Access Compliance Report

Public Rights-of-Way

Intersection ID: 47613	Main Street: BATHURST_DR	Cross Street: MACQUARIE_LN	Location: SW
ADA ID: BC75089D20BE	Ramp Type: PerpDiag	Initial Pass/Fail: Fail	Overall Compliance: No
		Severity Score: 8.75

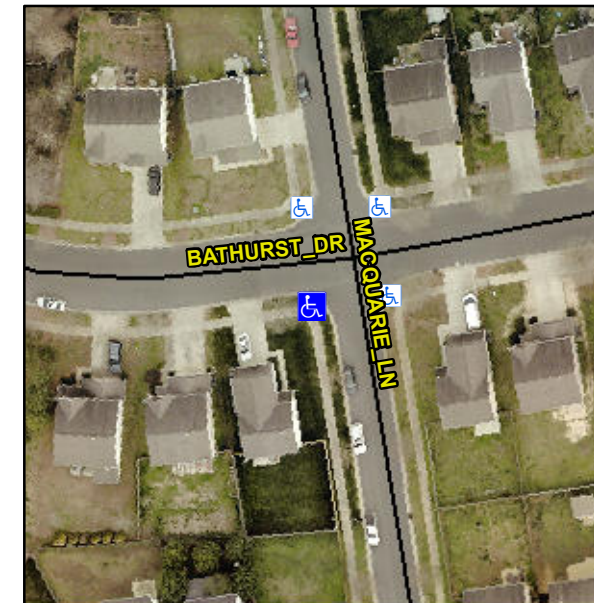
Not Found, R304.5.1

Compliance	Description	Data	Compliance	Description	Data
N/A	Ramp Length (in)	69.0	Yes	Ramp Slope (%)	5.2
No	Ramp Width (in)	45.5	Yes	Ramp XSlope (%)	1.2
N/A	Flare Type LT	N/A	N/A	Flare Type RT	N/A
N/A	Flare Slope LT (%)	N/A	N/A	Flare Slope RT (%)	N/A
N/A	Flare Traversable LT?	N/A	N/A	Flare Traversable RT?	N/A
N/A	Landing Length (in)	N/A	N/A	DWS Provided?	N/A
N/A	Landing Width (in)	N/A	N/A	DWS Contrast?	N/A
N/A	Landing Slope (%)	N/A	N/A	DWS Length (in)	N/A
N/A	Landing X Slope (%)	N/A	N/A	DWS Full Width?	N/A
N/A	Landing Curb? (Y/N)	N/A	N/A	DWS Offset (in)	N/A
N/A	Shared Landing?	N/A			
N/A	Gutter Ponding?	N/A	N/A	Gutter Slope (%)	N/A
N/A	Gutter Lip Ht (in)	N/A	N/A	Gutter X Slope (%)	N/A
N/A	Painted X Walk1?	No	N/A	Painted X Walk2?	No
	X Walk 1 Direction	To E		X Walk 2 Direction	To N
N/A	X Walk 1 Width (in)	N/A	N/A	X Walk 2 Width (in)	N/A
	X Walk 1 Slope (%)	3.4		X Walk 2 Slope (%)	5.0
	X Walk 1 X Slope (%)	1.2		X Walk 2 X Slope (%)	3.8

Remove & Replace Curb Ramp With Two New Directional Ramps or Equivalent.
